TOWN OF HORIZON CITY
Planning and Zoning Commission Staff Report

Case No.: **SDP25-0006 Verdancia Unit 4 Preliminary Phase 1**
SDP25-0007 Verdancia Unit 4 Preliminary Phase 2

Application Type: **Preliminary Plat**

P&Z Hearing Date: January 19, 2026

**PROPOSED TYPICAL 54' ROW STREET SECTION DETAIL
(RESIDENTIAL SUB-COLLECTOR)**

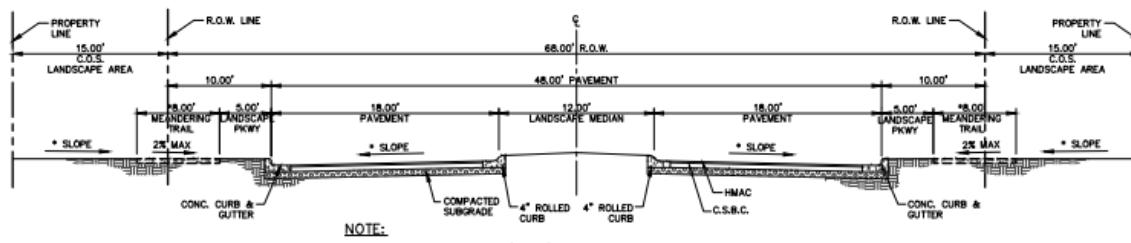
1. Modification from a 52-ft residential sub-collector street right-of-way to a 54-ft street right-of-way at all local residential sub-collector streets. The 54-ft street right-of-way will consist of two 5-ft parkways, two 5-ft wide concrete sidewalks and a 34-ft wide pavement structure with curb & gutter.

1. Modification from a 52-ft residential sub-collector street right-of-way to a 54-ft street right-of-way at all local residential sub-collector streets. The 54-ft street right-of-way will consist of two 5-ft parkways, two 5-ft wide concrete sidewalks and a 34-ft wide pavement structure with curb & gutter.

**PROPOSED TYPICAL 68' ROW STREET SECTION DETAIL @ ENHANCED ENTRANCE
(DUNE FLOWER PARKWAY RESIDENTIAL COLLECTOR)**

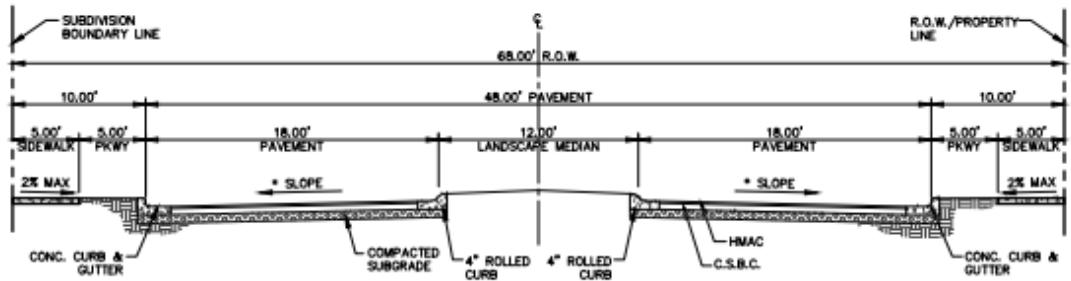
2. Modification to use a 68-ft residential collector at enhanced neighborhood entrances. The 68-foot street right-of-way will consist of two 5-ft parkways, two 5-ft wide concrete sidewalks, two 18-ft wide pavement structures and a 12-ft raised landscape median with curbs & gutter. Landscape areas will be maintained by the HOA.

2. Modification to use a 68-ft residential collector at enhanced neighborhood entrances. The 68-foot street right-of-way will consist of two 5-ft parkways, two 5-ft wide concrete sidewalks, two 18-ft wide pavement structures and a 12-ft raised landscape median with curbs & gutter. Landscape areas will be maintained by the HOA.

**PROPOSED TYPICAL 68' ROW STREET SECTION DETAIL @ ENHANCED ENTRANCE
(DESERT MIST DRIVE RESIDENTIAL COLLECTOR)**

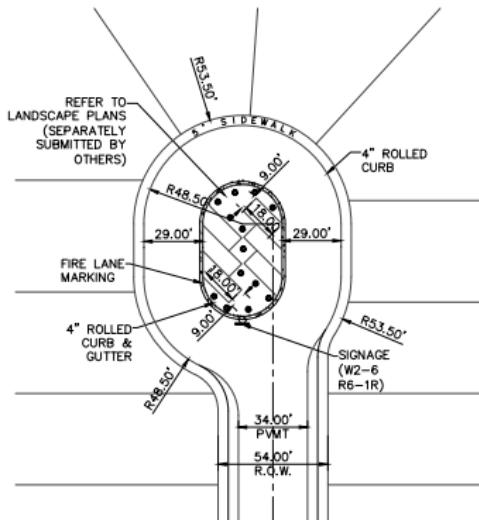
3. Modification to use a 68-ft residential collector with meandering trails at enhanced neighborhood entrances abutting common open space lots. The 68-ft street right-of-way will consist of two 5-ft parkways, 36-ft wide pavement structure with curb & gutter, a 12-ft raised landscape median and two 8-ft wide meandering trails. The 8-ft trails will meander within the street right-of-way parkway area and the adjacent 15-ft common open space landscape lot. This will provide a visually appealing and safe walking trail along this corridor. Landscape areas will be maintained by the HOA.

3. Modification to use a 68-ft residential collector with meandering trails at enhanced neighborhood entrances abutting common open space lots. The 68-ft street right-of-way will consist of two 5-ft parkways, 36-ft wide pavement structure with curb & gutter, a 12-ft raised landscape median and two 8-ft wide meandering trails. The 8-ft trails will meander within the street right-of-way parkway area and the adjacent 15-ft common open space landscape lot. This will provide a visually appealing and safe walking trail along this corridor. Landscape areas will be maintained by the HOA.

TYPICAL CUL-DE-SAC PARKING LAYOUT

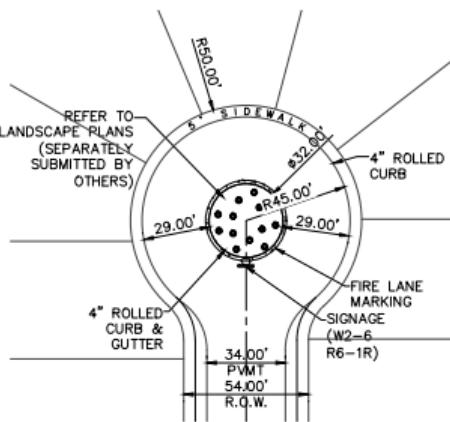
5. Variance from a 50-foot radius Cul-de-Sac street to a 53 ½ -foot radius cul-de-sac with interior parking/landscape islands and outside travel lane roadway width of 29-feet. The proposed cul-de-sac and parking/landscape islands will enhance the neighborhood character, reduce the impervious surface, aid to eliminate typical cul-de-sac "stack" parking while maintaining adequate room for emergency vehicle turning movement. Landscape areas will be maintained by the HOA.

5. Variance from a 50-foot radius Cul-de-Sac street to a 53 ½ -foot radius cul-de-sac with interior parking/landscape islands and outside travel lane roadway width of 29-feet. The proposed cul-de-sac and parking/landscape islands will enhance the neighborhood character, reduce the impervious surface, aid to eliminate typical cul-de-sac "stack" parking while maintaining adequate room for emergency vehicle turning movement. Landscape areas will be maintained by the HOA.

PROPOSED TYPICAL 54' ROW STREET SECTION DETAIL
(RESIDENTIAL SUB-COLLECTOR)

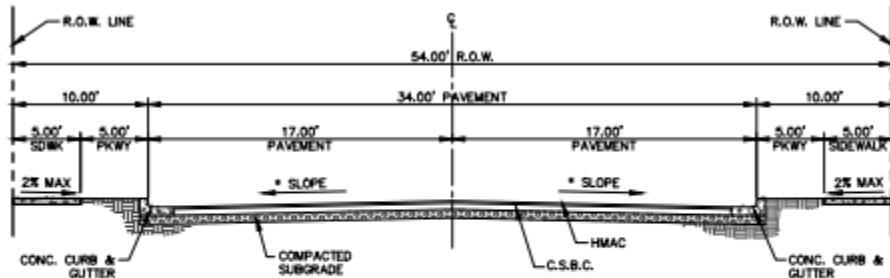
1. Modification from a 52-ft residential sub-collector street right-of-way to a 54-ft street right-of-way at all local residential sub-collector streets. The 54-ft street right-of-way will consist of two 5-ft parkways, two 5-ft wide concrete sidewalks and a 34-ft wide pavement structure with curb & gutter.

1. Modification from a 52-ft residential sub-collector street right-of-way to a 54-ft street right-of-way at all local residential sub-collector streets. The 54-ft street right-of-way will consist of two 5-ft parkways, two 5-ft wide concrete sidewalks and a 34-ft wide pavement structure with curb & gutter.
